The Nuclear Regulatory Commission has issued Amendment Nos. 44 and 38 to Facility Operating License Nos. DPR-42 and DPR-60 for the Prairie Island Nuclear Generating Plant, Unit Nos. 1 and 2, respectively, in response to your application dated May 6, 1980 as supplemented September 19 and December 2, 1980.

The amendments revise the common station Technical Specifications for the Prairie Island Nuclear Generating Plant Unit Nos. 1 and 2 with respect to the current logic for actuation of safety injection and with respect to the control rod and power distribution limits. During our review of your proposed amendments we found that certain modifications were necessary to meet our requirements. Your staff has agreed to these modifications and they have been incorporated in these amendments.

ATTACHMENT TO LICENSE AMENDMENTS NOS. 44 AND 38

SAFETY EVALUATION BY THE OFFICE OF NUCLEAR REACTOR REGULATION
RELATING TO AMENDMENT NO. 44 TO FACILITY OPERATING LICENSE NO. DPR-42
AMENDMENT NO. 38 TO FACILITY OPERATING LICENSE NO. DPR-60
NORTHERN STATES POWER COMPANY
PRAIRIE ISLAND NUCLEAR GENERATING PLANT UNIT NOS. 1 AND 2
DOCKET NOS. 50-282 AND 50-306

FIGURE TS.3.10-7

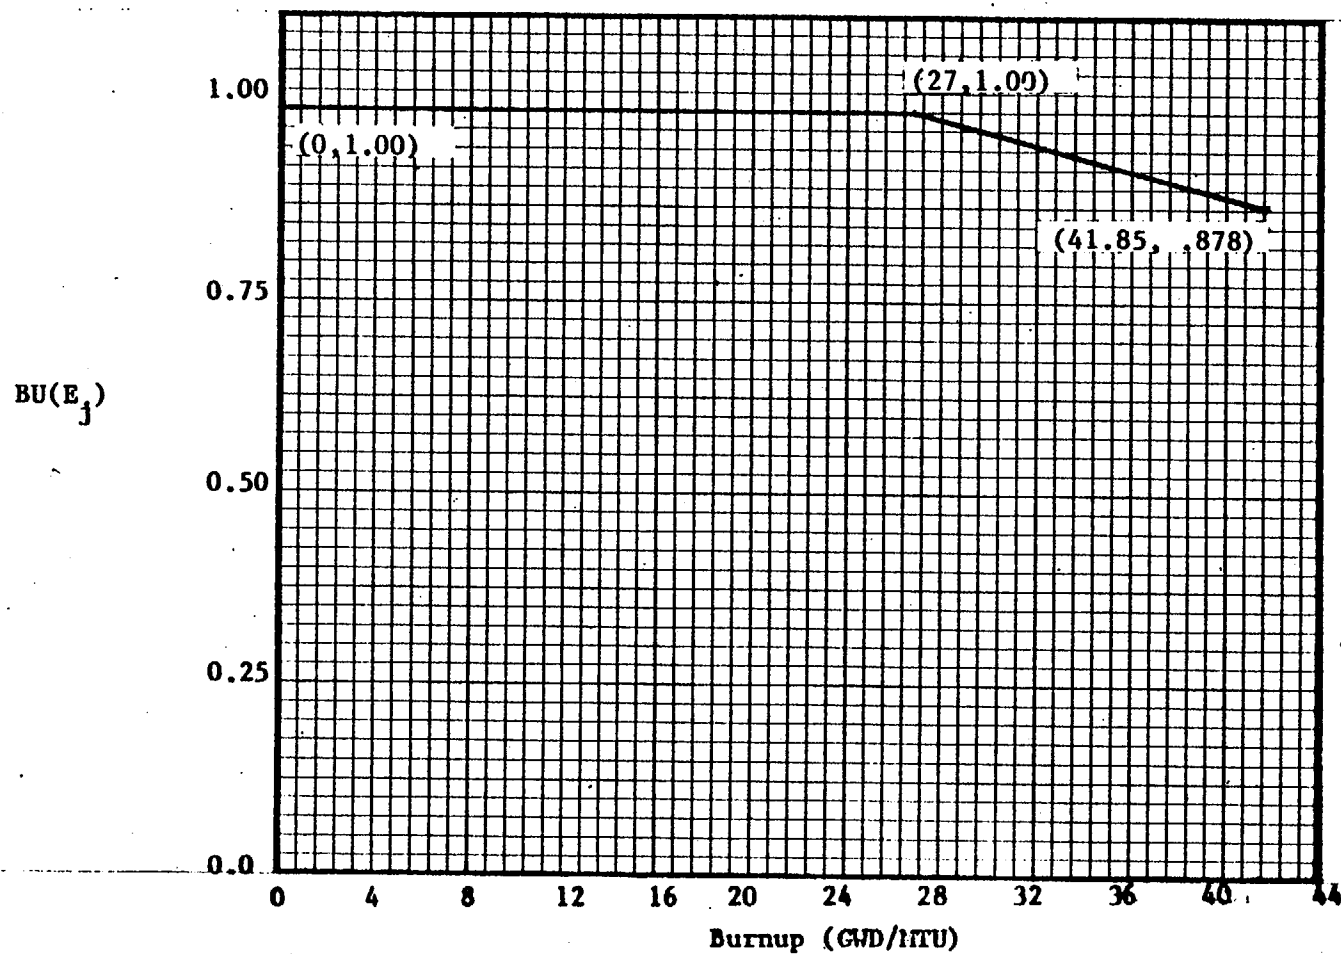
The $BU(E_j)$ function shown in Figure TS.3.10-7 is a normalized function that limits $F_Q(Z)$ based on exposure dependent analyses for the ENC fuel. These analyses consider pin internal pressure uncertainties, fuel swelling, rupture pressures, and flow blockage.

The licensee proposes to add an exposure dependent function which limits F_Q^N toward the top of the core at high exposures. This was done to conform with the NRC high fission gas release model. We reviewed the licensee's application of this model and agree that he has performed a conservative

$$F_Q^N \times 1.03 \times 1.05 \leq (2.21/P) \times K(Z) \times BU(E_j)$$

$$F_Q^N \text{ (equil)} \times V(Z) \times 1.03 \times 1.05 \leq (2.21/P) \times K(Z) \times BU(E_j)$$
